**Asian Development Bank Accountability Mechanism
Compliance Review Panel**

REPORT ON ELIGIBILITY

**To the Board of Directors
on
Compliance Review Panel Request No. 2013/1
on the Mundra Ultra Mega Power Project in India
(Asian Development Bank Loan 2419)**

27 December 2013

Satellite pictures showing mangroves and creeks – 2005 and 2013

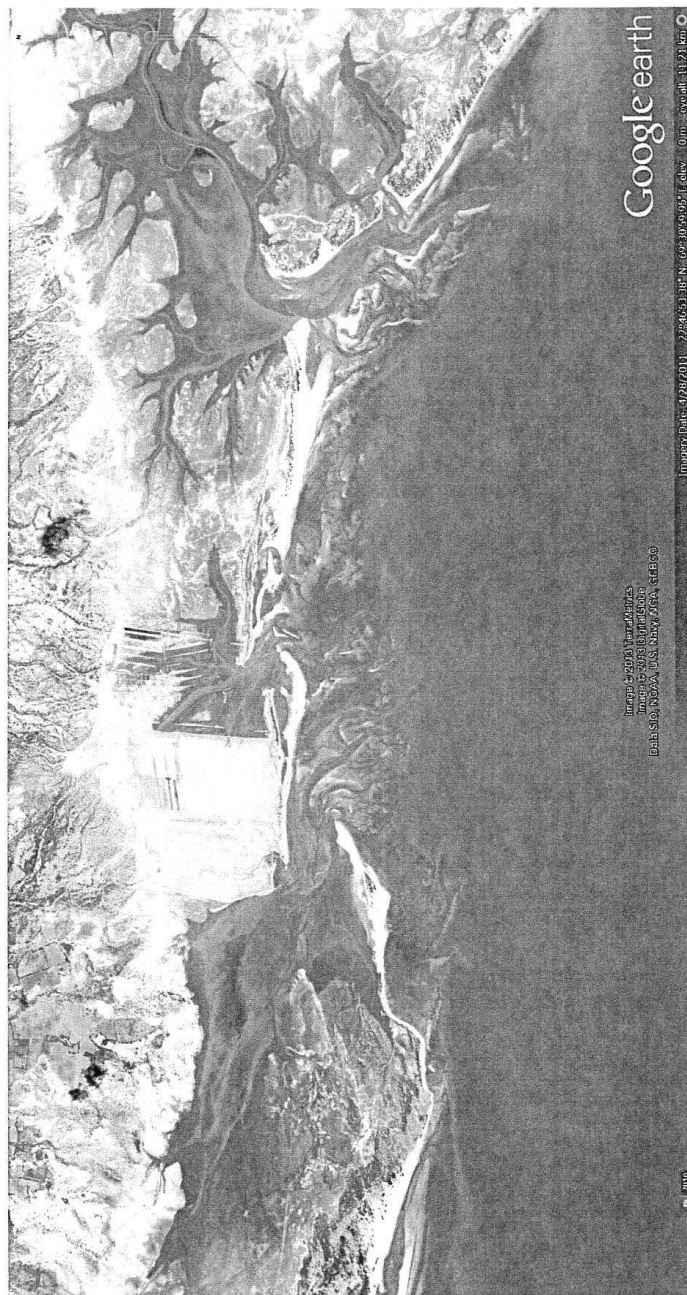
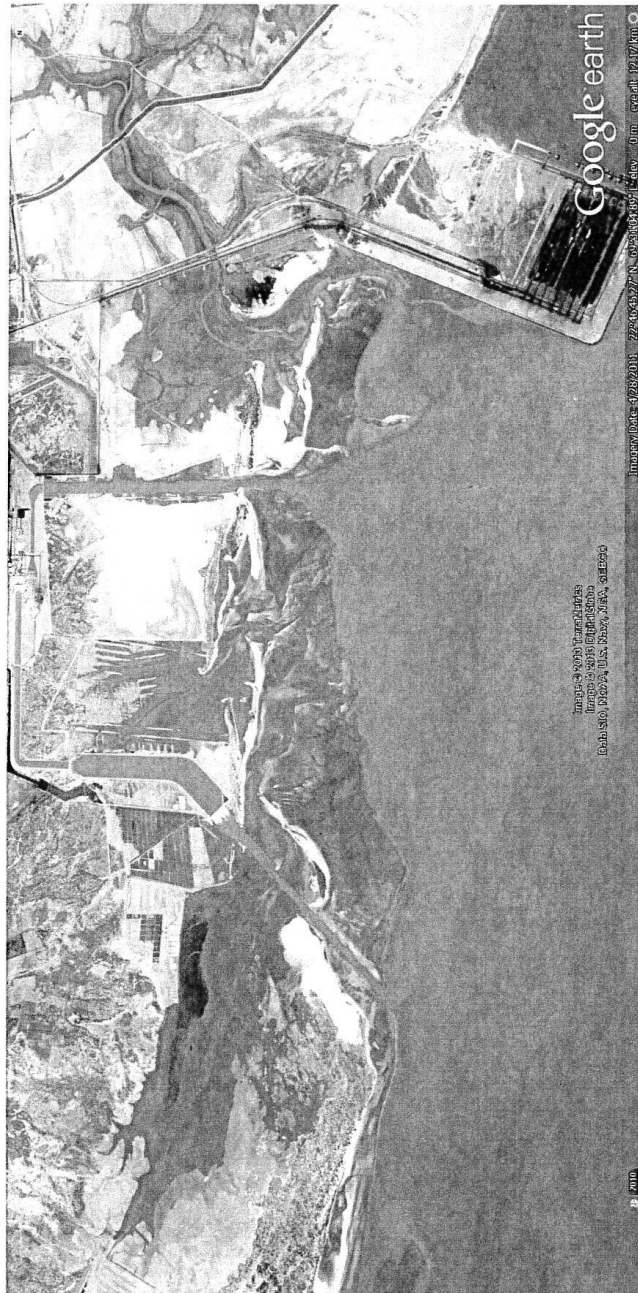
- *One of the major factors identified by almost all, was the **destruction of creeks and mangroves** (with the Adanis contributing in a much larger scale) – nurseries of marine life, as described earlier in this report. Both the Kothdi and Mudhwa creeks have been badly damaged by Tata’s dredging, widening and denudation.*
- *Another major factor identified by the fishing community is the **thermal pollution from the power plants – the warm cooling water coming out of their outfall channels**. This is a very large volume of warm water mixing with the gulf water here. The CGPL claimed*

ADB Response	Further Details/Evidence	On-going or future actions
	relation to salinity.		
12.	<p>Destruction of mangroves and creeks (Section C.1. Social 3.–p.4 of the Complaint and Section C.1. Environmental 1.–p.7 of the Complaint)</p> <p>A comparison of the satellite pictures which were taken in 2005 and 2013 does not evidence any destruction of mangroves.</p> <p>Based on the satellite pictures, destruction of creeks by the Project is limited to the area of 10-12% in Modhva creek. In the course of construction activity, CGPL (i) used a cutter suction dredger by which the dredged material was discharged through a floating pipeline to the shore; (ii) minimized the dredging period to the extent possible, thereby minimizing impacts on the creek.</p> <p>The SEIA identified the potential impact of dredging and recommended the use of excavated materials for filling the project area as a mitigation measure. A capital dredging plan and a maintenance dredging plan were prepared by CGPL, and submitted to MOEF before start of dredging work.</p>	<p>The satellite pictures are attached as Appendix 8.</p> <p>The volume of dredged spoil was approximately 2.1 million m³. The dredged material was used in the pre-cooling channel bund and bund protection. The remaining dredged material was utilized for site grading up to plant grade level beyond the CRZ area.</p>	<p>Tragadi village fisherfolks have noticed sedimentation opposite Tragadi bander and have requested maintenance dredging at the creek and stone pitching of the embankment between Tragadi bander and the weir. ADB has requested CGPL to incorporate this into its CSR program.</p>
